OSM/IN DECISION

Standard(s): EN 61643-11:2012 + A11:2018	Sub clause(s): 8.3.4 operating duty test	Sheet N°:	OSM/IN 289
Subject: Application of operating duty tests on SPDs in 1+1 or 3+1 connection Category: PROT	Key words: - operating duty - sample preparation	Meeting N°: Inquiry:	31 (2021) OSM-IN(Inq)-198_2021

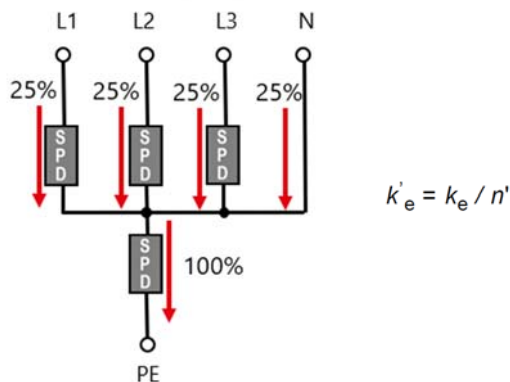
How to prepare and test the neutral-to-earth mode of multipole SPDs in 3+1 connection?

Acc. to EN 61643-11:2012 + A11:2018 SPDs have to be tested mode by mode of protection. This implies that for a multipole SPD in 3+1 connection design the neutral-to-earth mode including the internal wiring and the neutral terminal has to carry the full declared set of parameters. On the other hand, the installation of a multipole SPD requires connection to all poles in accordance with the manufacturer's installation instructions (see clause 8.1). Due to the special design of a 3+1 circuit the neutral-to-earth mode needs to be specified for the total current of all connected poles (modes), although in real world and according to EN 62305-1 Annex E each of the unshielded n' conductors of the line is expected to carry an equal part of the lightning current $k'_e = k_e / n'$; n' being the total number of conductors.

To ensure that the above service conditions are met, a symmetrical current injection as shown in figure 1 is being proposed as an option for the operating duty test of the neutral-to-earth mode. The same approach can be applied for SPDs in 1+1 connection.

The impulse tests acc. 8.3.4 on the neutral-to-earth mode of a multipole SPD in 3+1 connection may be performed by applying the impulse to all SPD modes according to the figure 1 above and ensuring a symmetrical current distribution. In this case the tolerances acc. table 21 shall be kept.

This is only applicable with the agreement of the manufacturer.

When the test is performed using all SPD modes, a symmetrical current distribution can be achieved by replacing the voltage limiting and voltage switching components of the line to neutral modes by appropriate copper blocks (dummies).

This replacement has to be done by the manufacturer.
